ITEM 5. STAGE 2 DEVELOPMENT APPLICATION: 25-55 ROTHSCHILD AVENUE AND 5-13 ROSEBERY AVENUE ROSEBERY**FILE NO:** D/2015/1901**DEVELOPMENT APPLICATION NO:** D/2015/1901**SUMMARY****Date of Submission:** 23 December 2015**Applicant:** Karimbla Constructions (NSW) Pty Ltd**Developer:** Meriton**Owner:** Karimbla Properties (No. 49) Pty Limited**Cost of Works:** \$262,369,426

The subject application seeks consent for a Stage 2 detailed design allocation for Phase 1 and Phase 3 of the site for the construction of 6 buildings ranging in height from 5 to 7 storeys with 478 apartments and two child care centres.

Figure 21: Phasing plan submitted as part of the subject development application

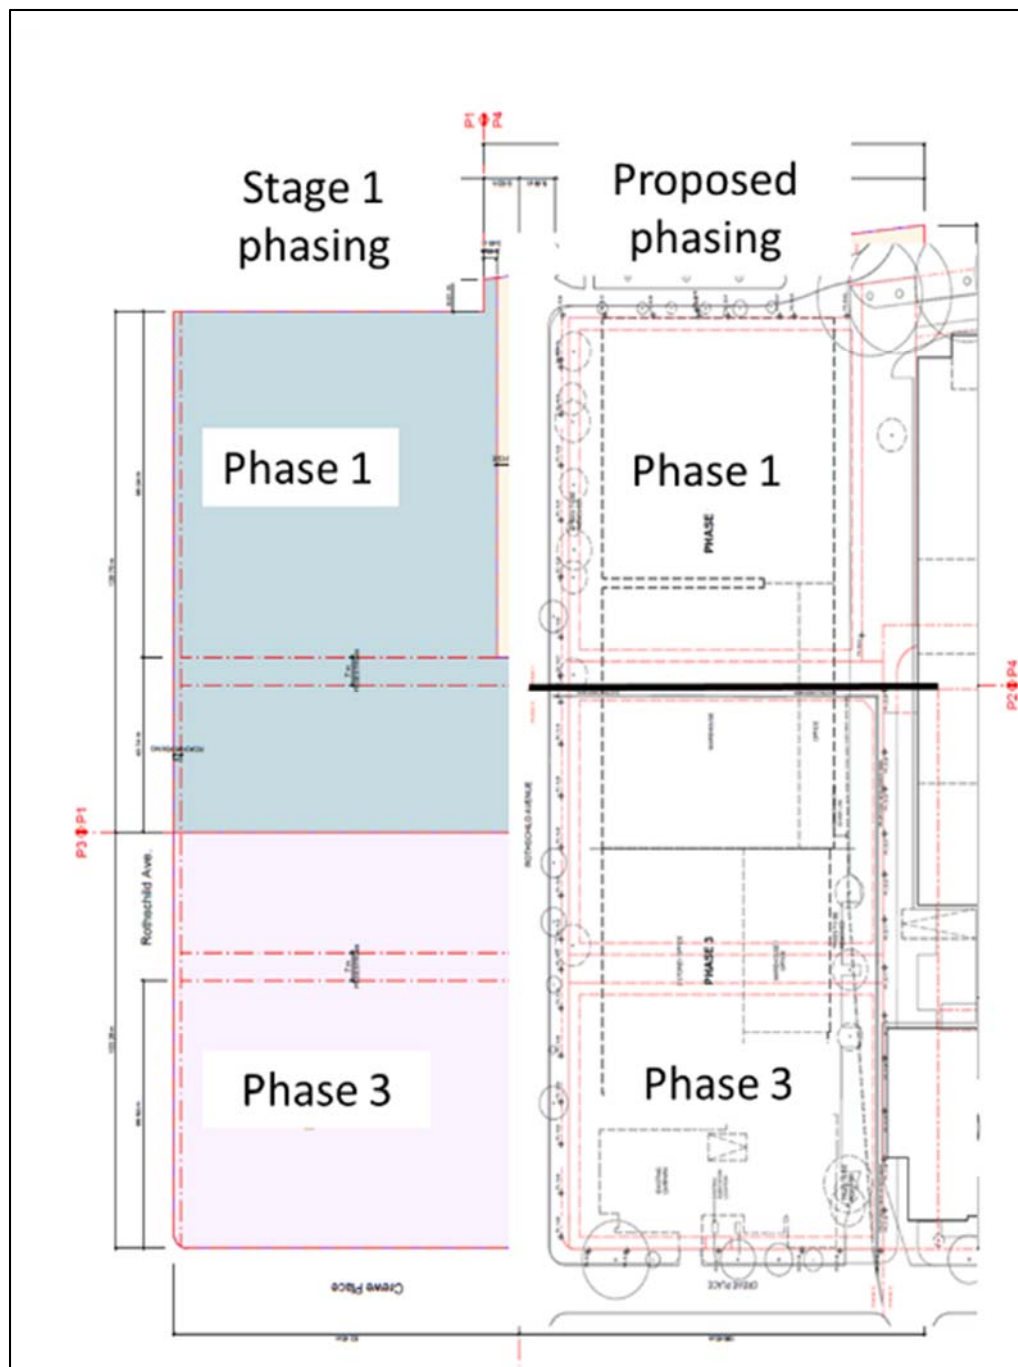
The Applicant has amended the delineation of the two Phases and each phase individually no longer complies with the alignment of phases within the Stage 1 consent.

56. The subject application does not seek to alter the staging of works which are required to be completed by the VPA which has been registered on title. The applicant will need to deliver the complete package of works for each Phase as approved under the Stage 1 consent and VPA.
57. An assessment of compliance with the Stage 1 conditions of consent is provided below:

Figure 22: Ground floor building 1B – study windows are within an internal circulation corridor and in close proximity to each other.

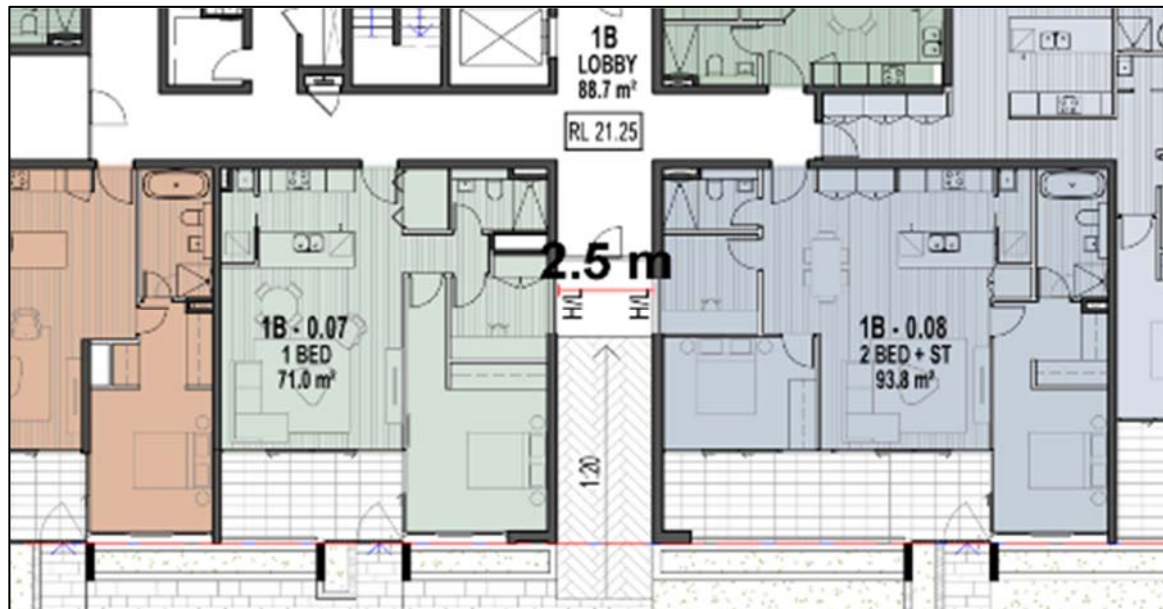
66. Several apartment types have compromised amenity due to either failing to minimise building separation, internal windows within the building or have windows within close proximity to banks of air conditioner units, Figures 22 -24 illustrate the issue.

- (a) No residential apartment windows for habitable rooms are to be located within walkways, lobbies, common circulation space or internal corridors at the ground floor level. Specifically windows in apartments: 3A0.04, 3A0.05, 1A0.06, 1B0.05, 1B0.07, 1B0.08, 1B0.09, 1B0.13 and 1B0.14 are to be removed.
- (b) The following apartments are to be reconfigured to remove study windows in close proximity to banks to air conditioner units, 1A 1.08, 1B 1.09, 1A 2.08, 1B 2.09, 1A 3.08, 1B 3.09, 1A 4.08, 1B 4.06, 1A 5.07, 1B 5.06 and 1A6.07.

67. It is recommended as a condition of consent that the internal windows within lobbies and circulation spaces as shown in Figure 20 be removed. Each of these apartments will need to be reconfigured.
68. Several apartment types within the 'elbows' of building's 1A and 1B fail to provide adequate separation between windows and banks of air conditioner units as shown in Figures 21-22 above. It is unlikely that the proposed windows in this arrangement would be untiled given the noise and heat load experienced by occupants. It is recommend as a condition of consent that the windows be removed. Each of these apartments will need to be reconfigured.

Figure 27: View analysis provided by applicant for the original scheme

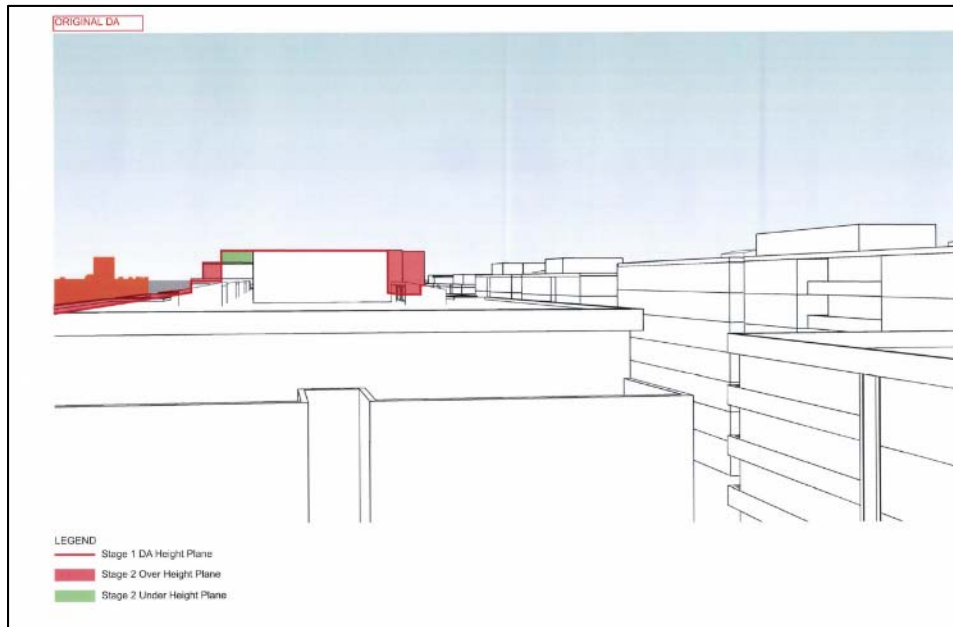
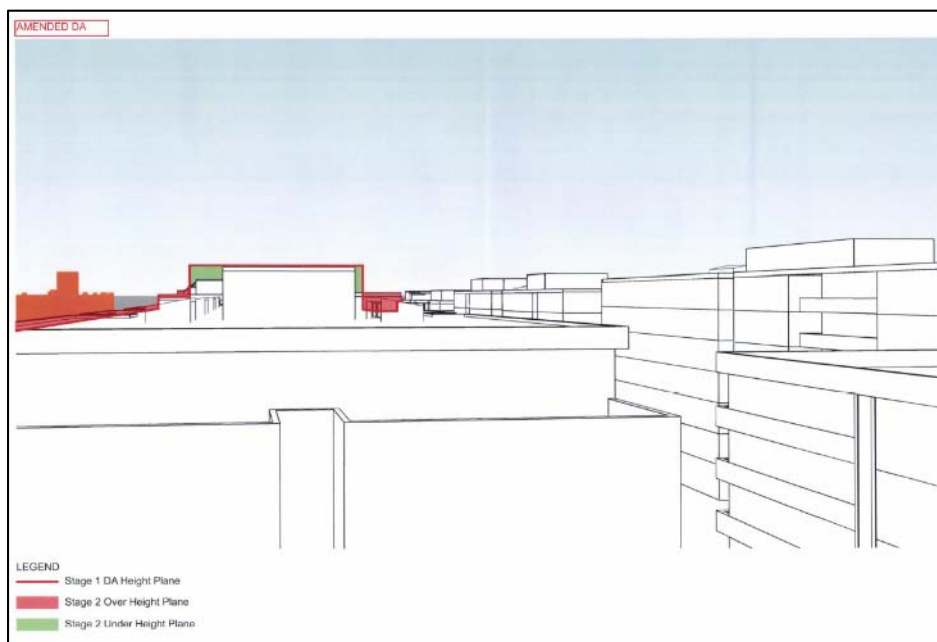
83. The analysis of the original submitted scheme shows that some additional view loss may occur. This is due to the location and design of the rooftop structure such as stairs and plant. These rooftop structures have been redesigned (at the request of Council Officers) and there will be a reduced impact as shown on the amended DA view analysis from the original scheme submitted. The reduction does not reduce the impact on the existing view of waters of Botany Bay to the south of the site.

85. It is not considered that the view analysis sufficiently addresses view loss as all the existing view to the waters of Botany Bay will be lost. This does not constitute view sharing. It is recommended as a condition of consent that further efforts are made to reorientate and relocate the rooftop plant to allow view sharing to occur. Further it is recommended that detailed plans with fine grain details and materials will be required to be submitted to Council prior to the issue of a construction certificate.
